The following table provides an assessment of the potential environmental effects resulting from changes in the definition of the East Bay BRT Project. The changes are relatively minor and include the elimination of a second through lane on International Boulevard (SR-185) between 73rd and 75th Streets and the elimination of three new traffic signals.

TABLE 2: IMPACTS ASSESSMENT FOR PROPOSED INTERNATIONAL BOULEVARD STRIPING CHANGES AND SIGNAL ELIMINATION DESIGN CHANGES TO THE EAST BAY BRT PROJECT

Figure 2: Signal Elimination

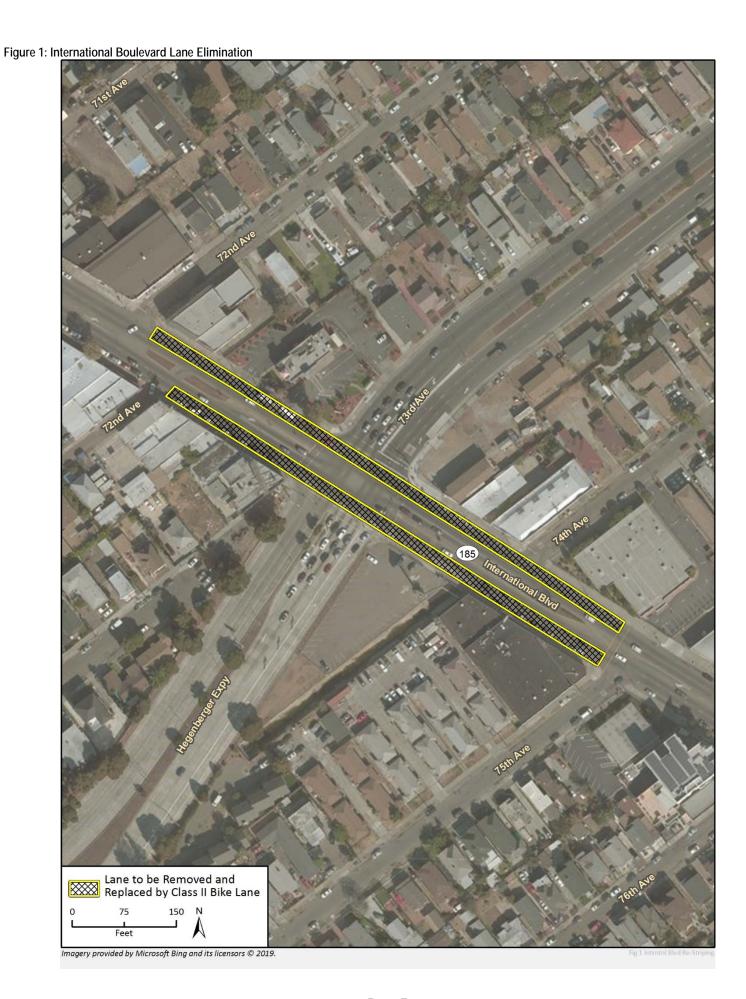
An aerial view of the proposed lane elimination is provided in Figure 1 and the proposed signal eliminations are shown in Figure 2.

Proposed Location	Change from FEIS/R	Description
Lane elimination: International Boulevard (SR-185) between 73rd and 75th Streets, Oakland CA. Signal elimination: International Boulevard at the intersections of 13th and 12th Avenues and the intersection of 12th Street and 13th Avenue.	Elimination of elements previously included in FEIS/R analysis	The proposed design changes to the East Bay BRT Project include the elimination of one of the through-lanes of traffic in the southbound direction of International Boulevard between 72nd and 75th Avenues in Oakland, California, and the addition of parking/delivery lane space and Class II bike lanes. These changes are shown in Figure 1 and Figure 2 and would be accomplished by restriping International Boulevard as proposed. No major construction work is required. The second proposed change is elimination of three new traffic signals planned for construction in the approved BRT Final Design, which have since been determined to be unnecessary for the projected traffic volumes (International Boulevard/13th Avenue, International Boulevard/12th Avenue, and 12th Street/13th Avenue). These changes are described in the memorandum by Fehr & Peers titled "7229 International Boulevard – Maria's Market and Deli" dated September 21, 2018.
